Response to reviewer comments on the journal paper "The Thermodynamics of Urmophane Dissolution and Growth in CaCl_2 - SiO_2 (aq) Test Solutions" submitted to *Geochimica et Cosmochimica Acta*.

The original manuscript was submitted to *Geochimica et Cosmochimica Acta* in May, 2007. Comments from two anonymous reviewers and an associate editor were received in July, 2007.

Based on reviewer comments the following revisions were made to the GCA paper on uranophane solubility.

Fig 2. The pH + concentrations of Ca, Si, + U in Tests D-0A + D-0B.

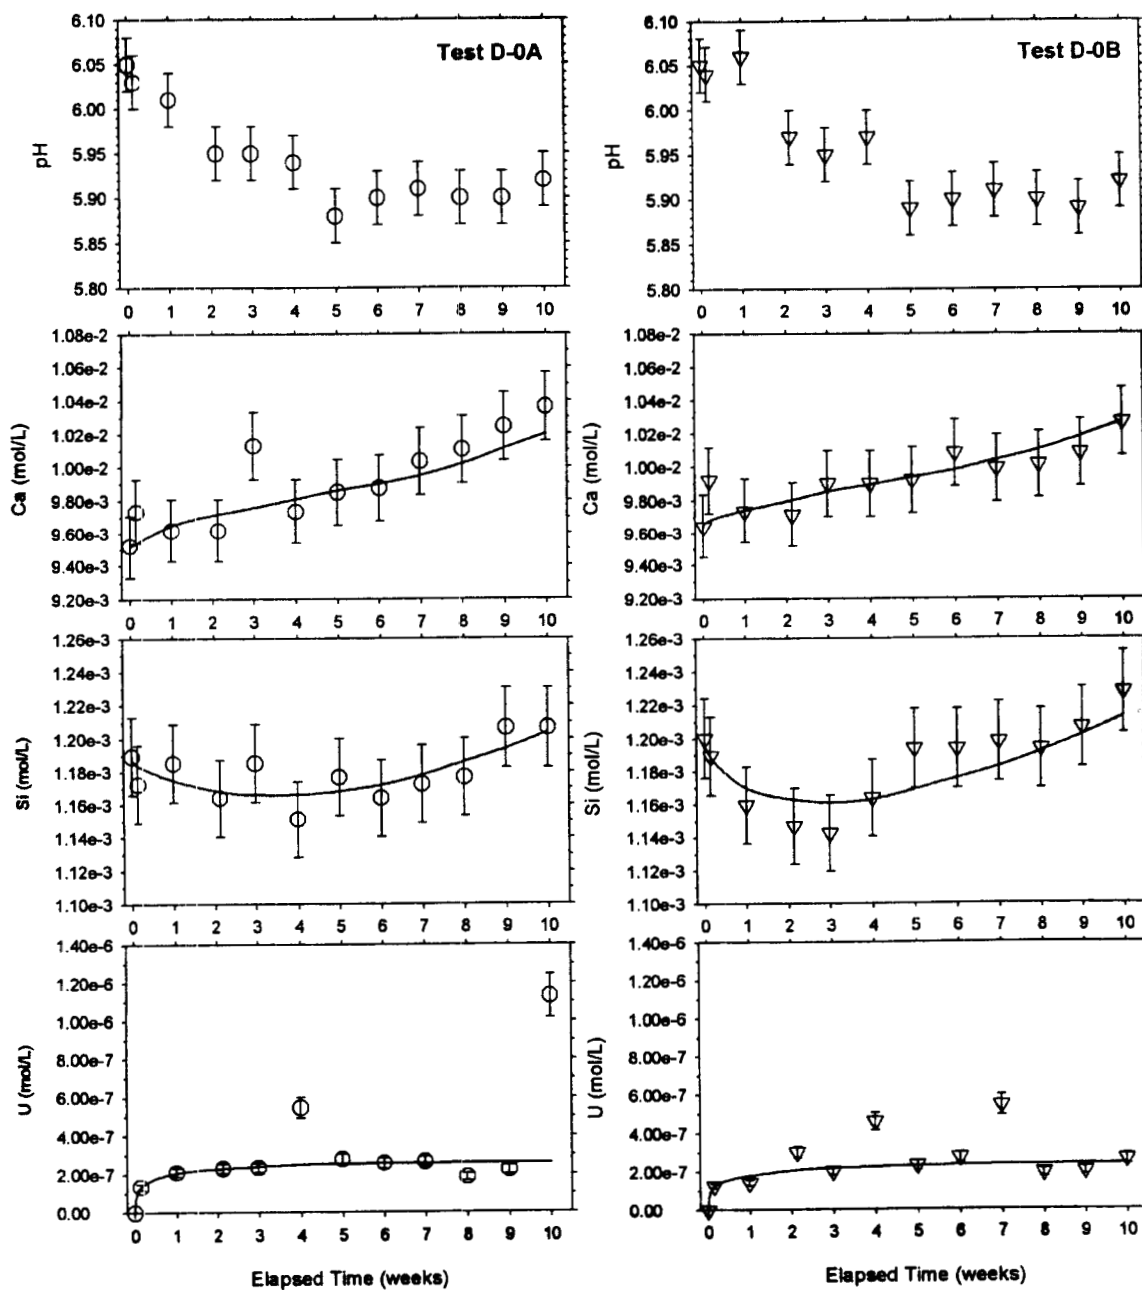
- pH and cation concentration data were replotted in Figures 2, 3, and 4 so that trends could be more easily discerned.

In addition error bars showing analytical uncertainty in pH and cation analyses were added to the figures.

- To address concerns about attainment of equilibrium, regression analyses were performed on measured Ca, Si, + U concentrations data to eliminate some of the uncertainty + variation in the mass transfer data.

Analytical uncertainty were ± 0.03 pH units for pH, $\pm 2\%$ for Ca and Si contents, and $\pm 10\%$ for U analysis.

Regression analyses were performed using the Regression Wizard in SigmaPlot Ver 8. Before performing the regression, spurious analytical data for Ca and U were removed. For Ca these data included week 3 of test D-0A, + week 10 of D-7B. For U these data included week 4 + 10 of D-0A, week 4 + 7 of D-0B, week 7 of D-7A, and weeks 6 + 10 of D-7B, weeks 3 + 10 of P-1A, and weeks 5, 6, 9, + 10 of P-1B.

Best fit curves for the regression analyses are shown in Figs 2, 3, + 4 on the previous pages.

Fig 5. Net moles of Ca, Si, + U released to solution in dissolution tests.

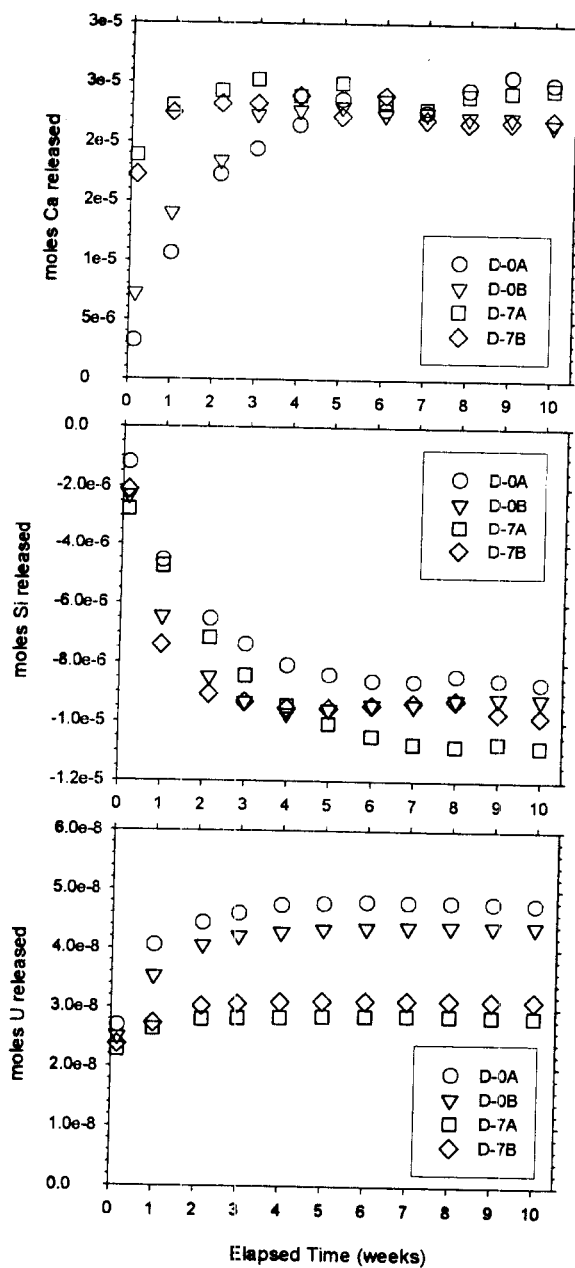
Based on calculated values from the regression analyses, mass transfer data (i.e., net moles of Ca, Si, + U released to solution) as a function of time were replotted for the duplicate tests in Fig 5 + for the triplicate tests in Fig 6. These figures are shown on the following pages and show good evidence for equilibrium in the latter parts of the tests.

Fig 7. Calculated log Q_s plotted as
 function of time.

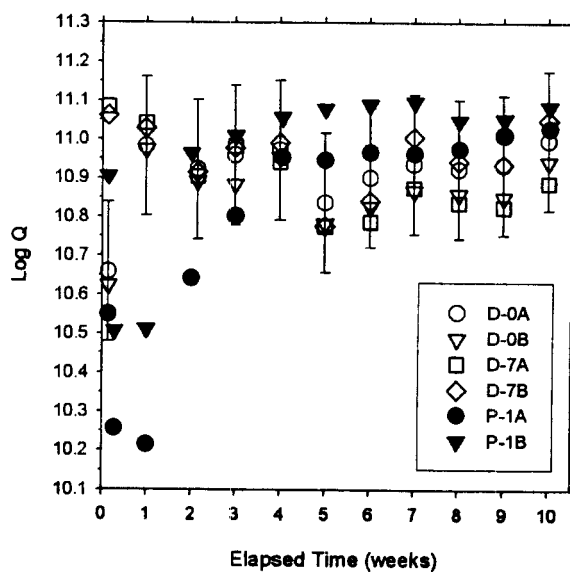
Log Q_s were recalculated using measured test solution pH and calculated Ca, Si, & U concentrations based on the regression analysis. Recalculated log Q_s were replotted as Figure 7 which is shown below.

Error bar showing possible range in calculated log Q values resulting from error in pH measurement (± 0.03 pH units) are shown for test D-0A in Fig 7.

The possible error range for DOA results from error in pH measurement could be expected for all test solutions.

Figure 8. SEM photomicrographs showing (A) unreacted synthetic uranophane, (B) uranophane recovered from test D-0B, (C) uranophane recovered from test P-1A, and (D) particles other than uranophane recovered from test P-1A.

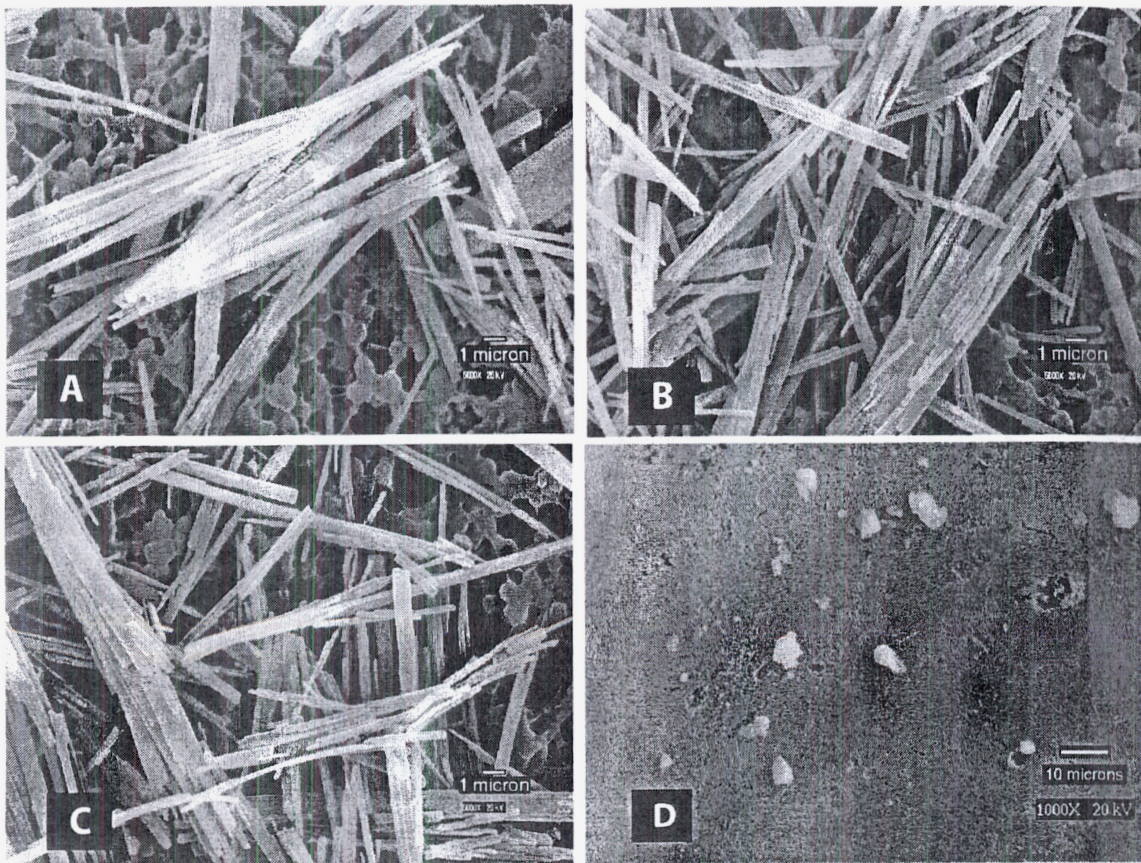
11/29/07 JP • Evaluation of Solids Precipitation Section (4.2) was revised to include discussion of SEM + XRD characterization of recovered solids.

Results of SEM + XRD analysis did not show evidence for strong leaching of samples treated or solids precipitated. A Figure (Figure 8) was included in the paper which detailed results of the SEM analysis. The Figure is shown on the next page.

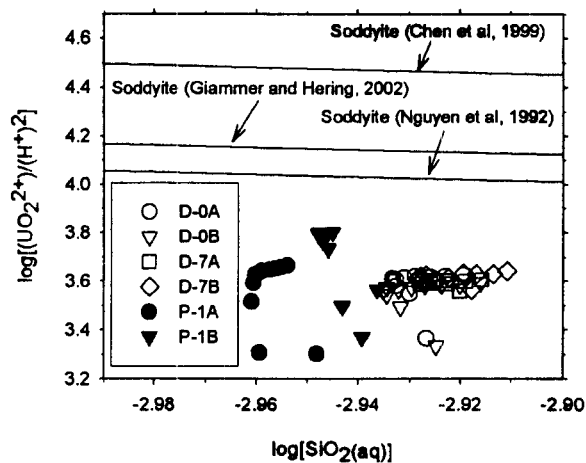
The $\log$ activity diagram of $\text{UO}_2^{2+}/(\text{H}^+)^2$ versus $\text{SiO}_2(\text{aq})$ plotting the points of the test solution with respect to the solubility limit of soddyite was replotted using UO_2^{2+} , H^+ , and $\text{SiO}_2(\text{aq})$ activities derived from the regression analysis. This diagram was replotted in Figure 9 and is shown below.

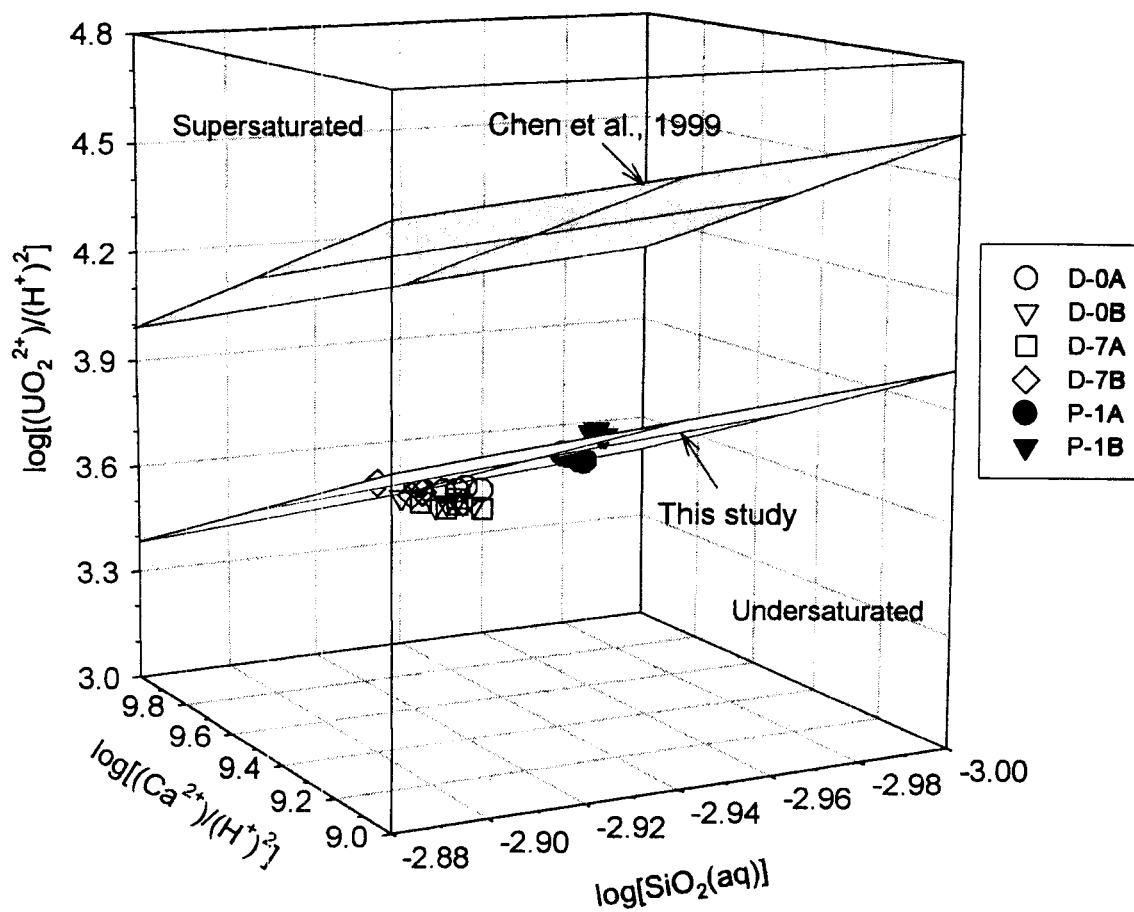
- The log activity diagram of $\text{UO}_2^{2+}/(\text{H}^+)^2$ versus $\text{SiO}_2(\text{aq})$ versus $\text{Ca}^{2+}/(\text{H}^+)^2$ was replotted in Figure 10 to reflect recompiled UO_2^{2+} , $\text{SiO}_2(\text{aq})$ & Ca^{2+} activities. Figure 10 is shown below. For last 5 supply runs.
